1968 Corvette: Service Bulletin: Gas Line Rattle

Subject: Gas Line Rattle

Bulletin No: 68-IC-54

Date: June 29, 1968

Fig. 1.

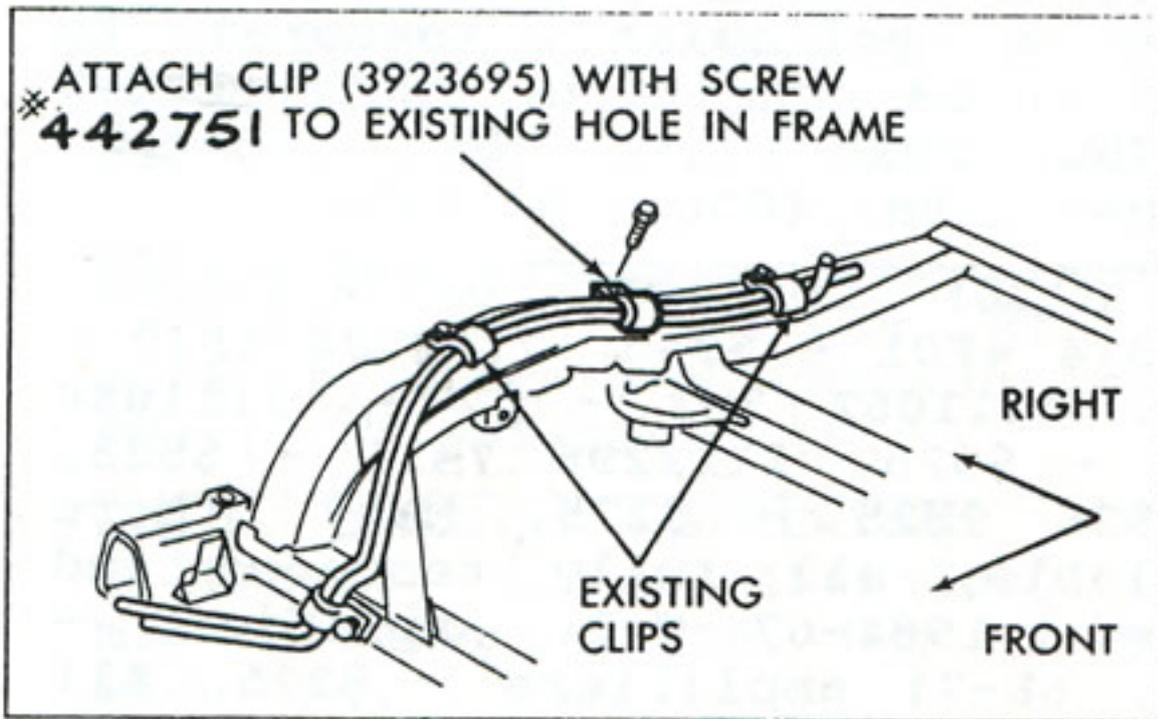
A rattling or "ticking" noise from the rear of the vehicle has been experienced on some 1968 Corvettes. This noise is resulting from the fuel supply line vibrating against the return line. Production has corrected this condition by installing an additional clip in the existing frame hole at this location. Refer to Fig. 1. This same correction is recommended for units in the Field that are experiencing the rattling or "ticking" noise. Fig. 1 illustrates where the clip should be added and gives the related parts data.
